## **Proposed Change as Submitted**

**Proponent:** Ed Kulik, representing ICC Building Code Action Committee (bcac@iccsafe.org)

### **SECTION 3114 INTERMODAL SHIPPING CONTAINERS**

**G151-18**

**3114.8.5.3(1)**  
**Bracing Unit Distribution--Maximum Linear Length**

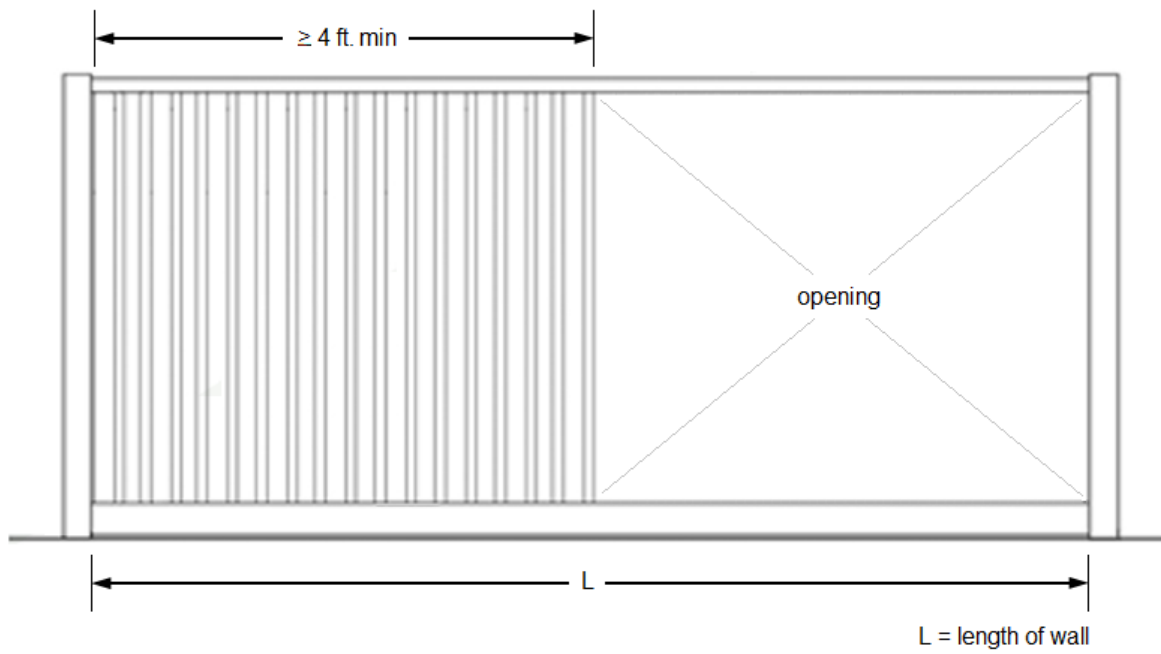
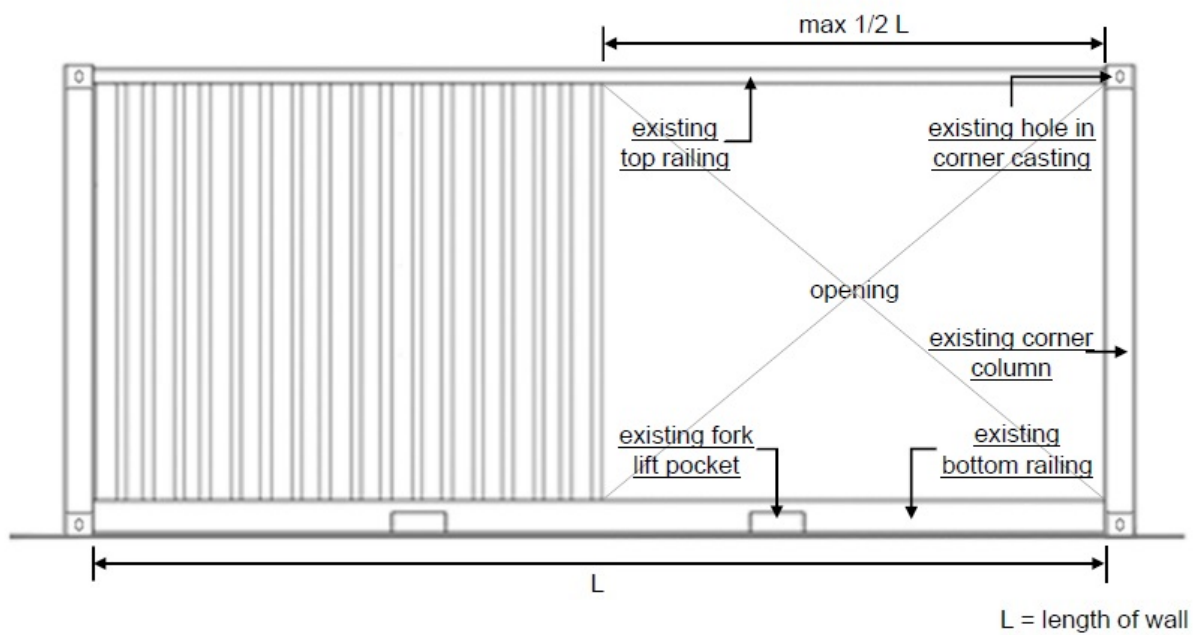
1. The total linear length of all openings in any individual side walls or end walls shall be limited to not more than 50% of the length of that side walls or end walls, as shown in Figure 3114.8.5.3(1).

Figures 3114.8.5.3 (1) through (4) – It was brought to our attention that it may be beneficial to identify parts of the intermodal shipping container more clearly rather than use a simple line drawing figure. This is for the benefit of the user to more readily recognize existing conditions versus the permissible cut-aways as allowed by Section 3114.8.5.3. In response we are proposing to add identifying text (the rails, lift slots, and holes) to illustrate those existing elements that are part of the manufacture of intermodal shipping containers.

**3114.8.5.3(2)**  
**Bracing Unit Distribution -- Minimum Linear Length**

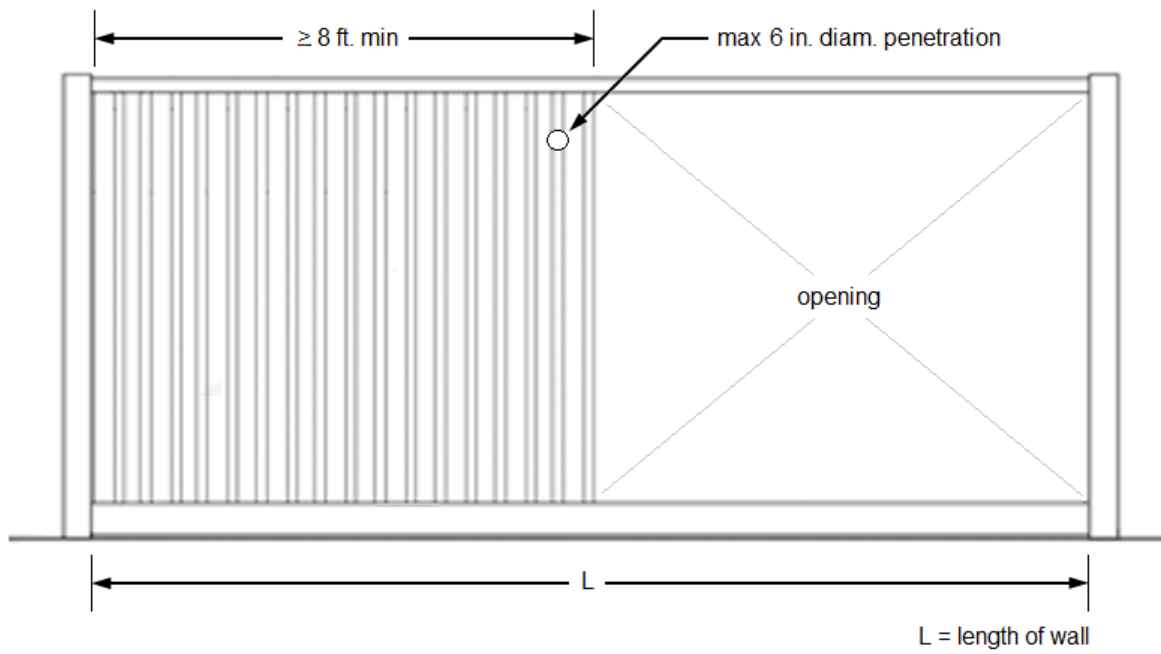
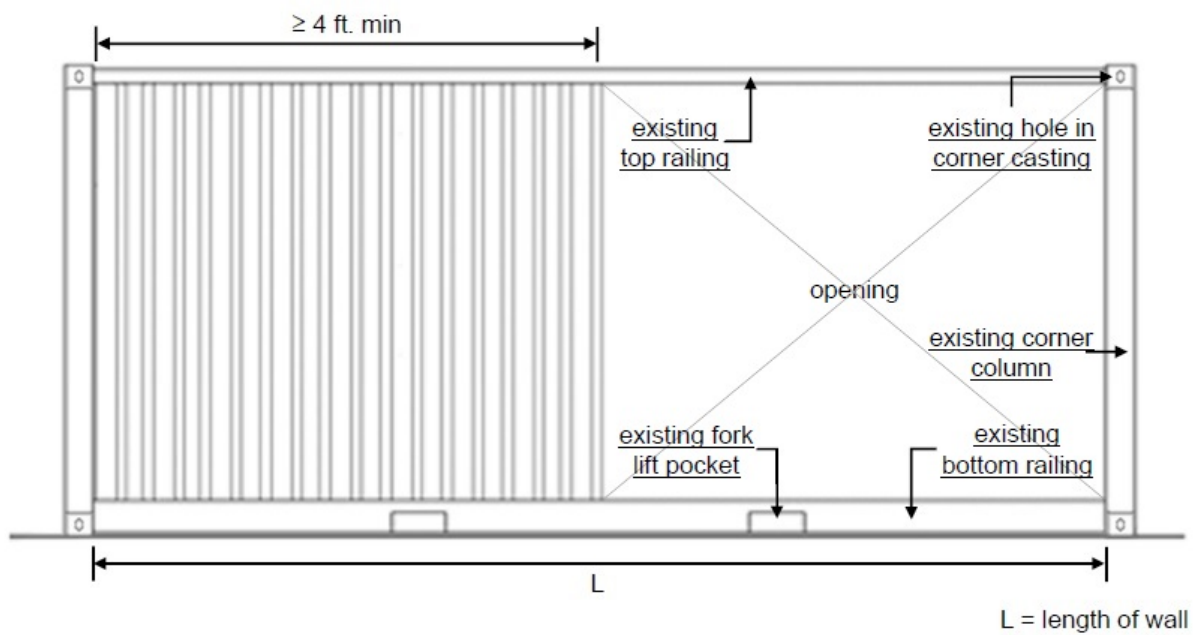
2. Any full height wall length, or portion thereof, less than 4 feet (305 mm) long shall not be considered as a portion of the lateral force-resisting system, as shown in Figure 3114.8.5.3(2).

**3114.8.5.3(4)**  
**Bracing Unit Distribution -- Penetration Limitations**

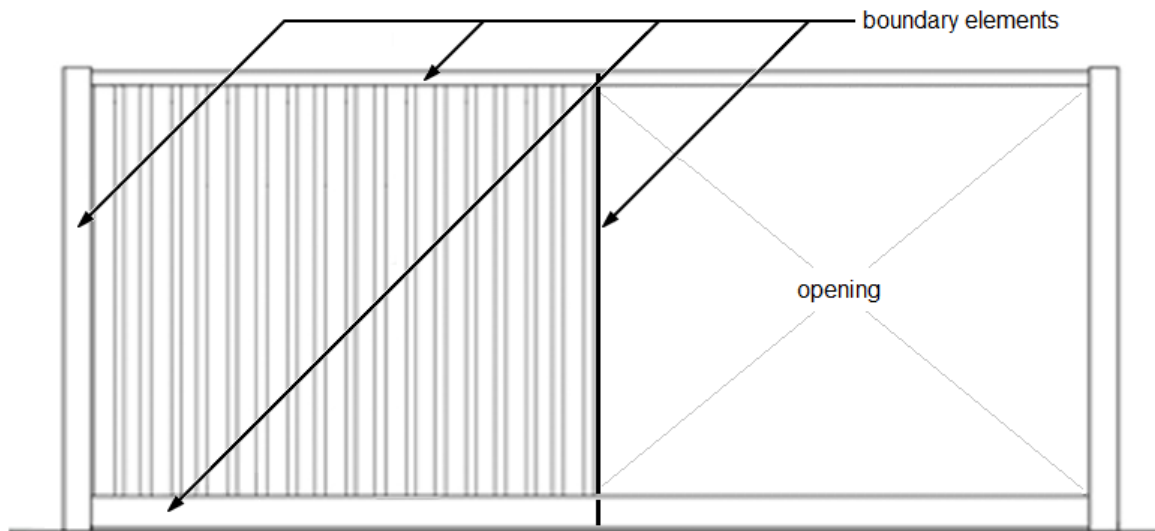
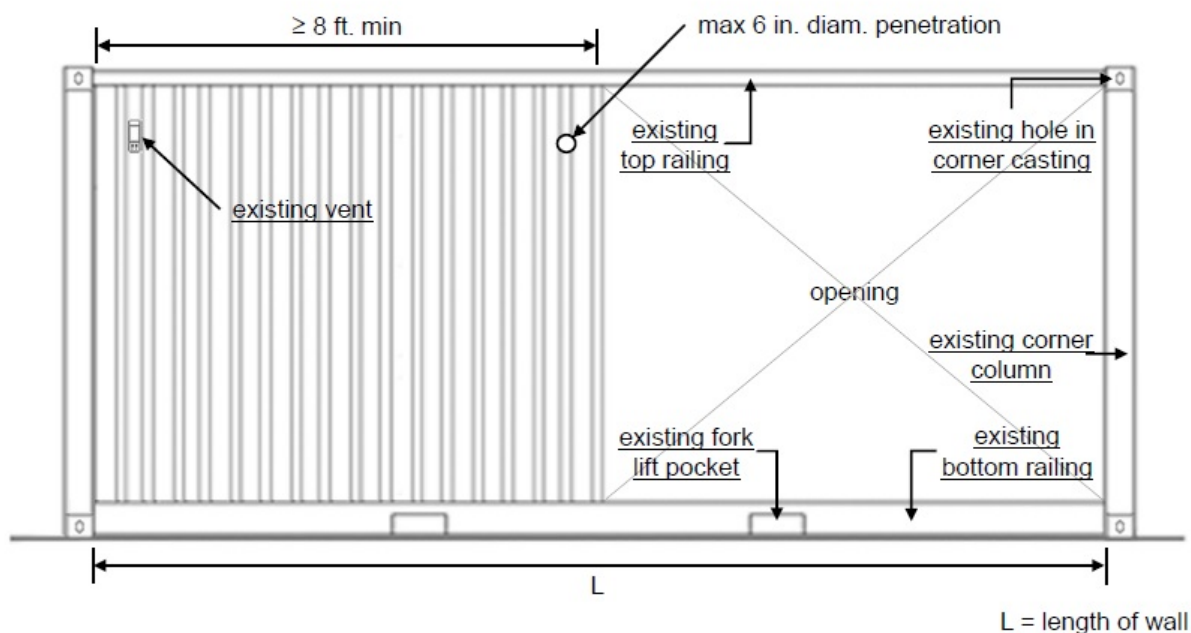
- 4.2. The cross section and material grade of any new steel element shall be equal to or greater than the steel element removed.
5. A maximum of one penetration not greater than a 6-inch (152 mm) diameter hole for conduits, pipes, tubes or vents, or not greater than 16 square inches (10,322 sq mm) for electrical boxes, is permitted for each individual 8 foot length (2,438 mm) lateral force resisting wall. Penetrations located in walls that are not part of the wall lateral force resisting system shall not be limited in size or quantity. Existing intermodal shipping container vents shall not be considered a penetration, as shown in Figure 3114.8.5.3(4).

**3114.8.5.3(3)**  
**Bracing Unit Distribution -- Boundary Elements**

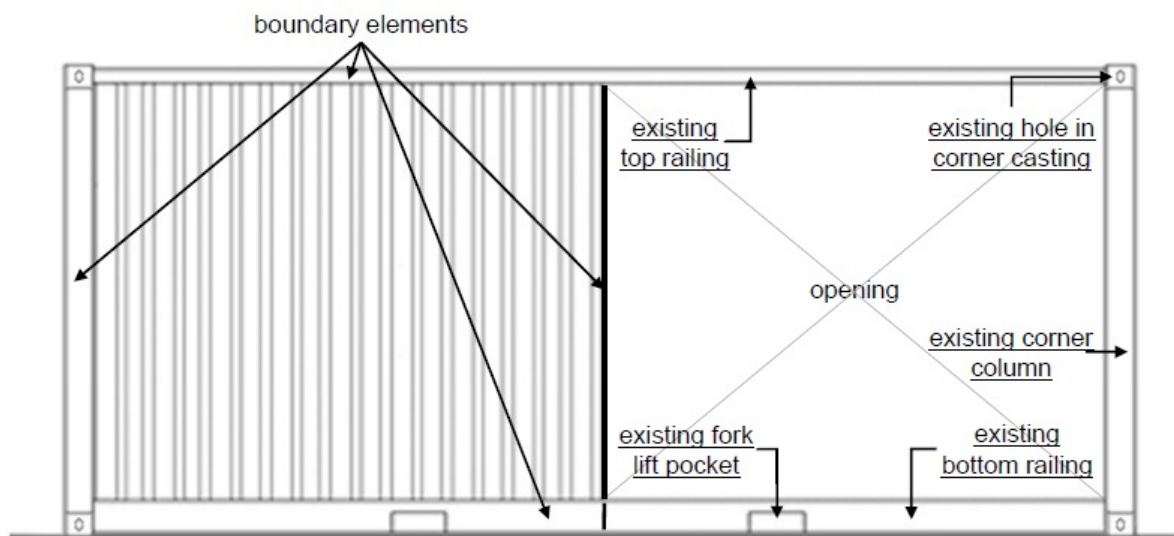
3. All side walls or end walls used as part of the lateral force-resisting system shall have an existing or new boundary element on all sides to form a continuous load path, or paths, with adequate strength and stiffness to transfer all forces from the point of application to the final point of resistance, as shown in Figure 3114.8.5.3(3).
